MEMORANDUM

SUBJECT: Ten Mile Creek Area Limited Amendment to the Clarksburg Master Plan and
Hyattstown Special Study Area

Subject: Draft Response to September 9, 2013 Geosyntec Letter

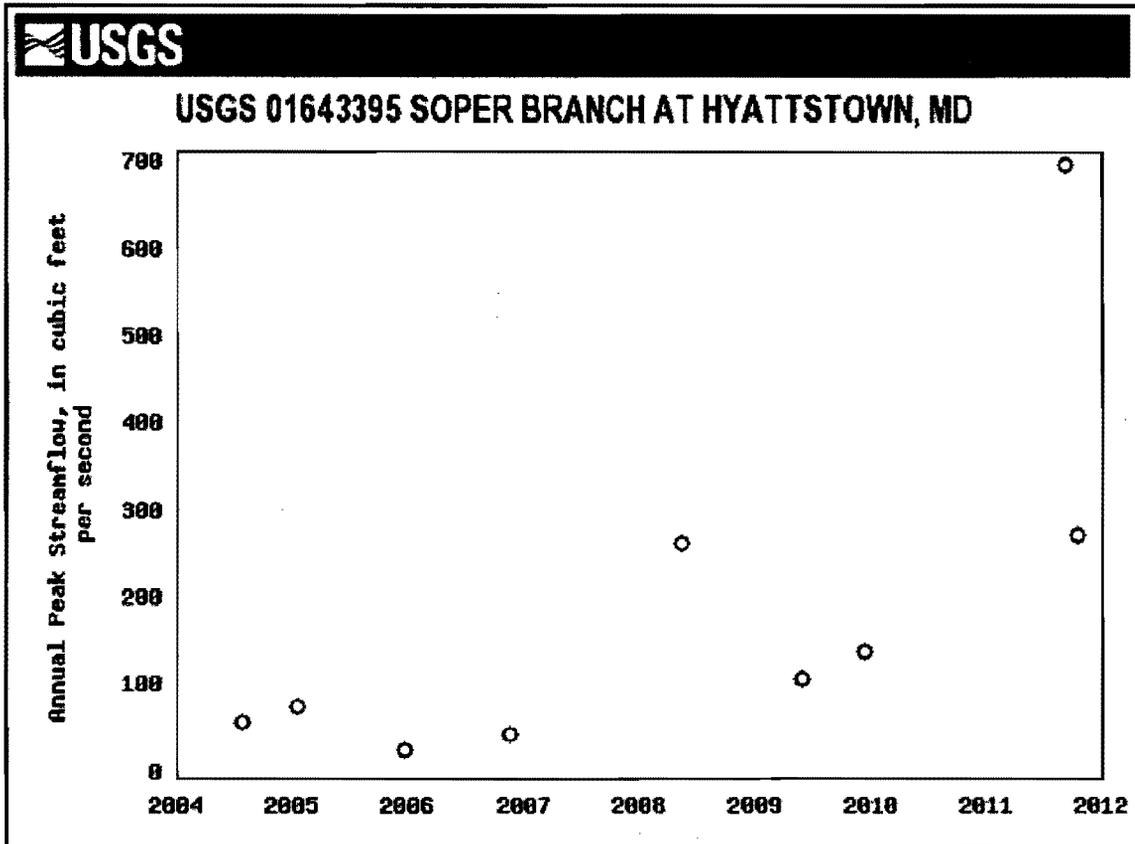
Geosyntec Comment: Existing conditions model results are well outside of independent predicted results and norms for the area....The MNCPPC's consultant's model appears to grossly underestimate peak flow rates in LSTM110 and LSTM111.

Response: We do not agree that the model grossly underestimated existing condition peak flow rates in LSTM110 and LSTM111.. Predicted peak flow rates are sensitive to various model algorithms and parameters, and can vary widely even within the range of accepted modeling methods and parameter values. The actual peak flow rates in LSTM110 and LSTM111 are unknown. Therefore, it is possible to arrive at different modeled predictions of peak flows under existing conditions. The Geosyntec comment letter cites three bases for comparison of predicted peak flows in LSTM110 and LSTM111:

1. USGS regression equations
2. Area-scaled continuous gage data from USGS gage 01644390—Ten Mile Creek Near Boyds, MD
3. Independent SWMM modeling

The USGS Regression Equation quoted by Geosyntec is several years old. USGS has updated the regressions and present data on the USGS stream statistics web site (http://streamstatsags.cr.usgs.gov/md_ss/default.aspx?stabbr=md&dt=130239302542270000). For a basin in the vicinity of the basins in question, this web site suggests a peak 2-yr flow of about 50 cfs for the 211-acre basin 110, which is greater than the value predicted by the Joint Venture but less than the value cited by Geosyntec. The Geosyntec model predicts peak 2-year flows twice the older USGS values and three times the more recent values.
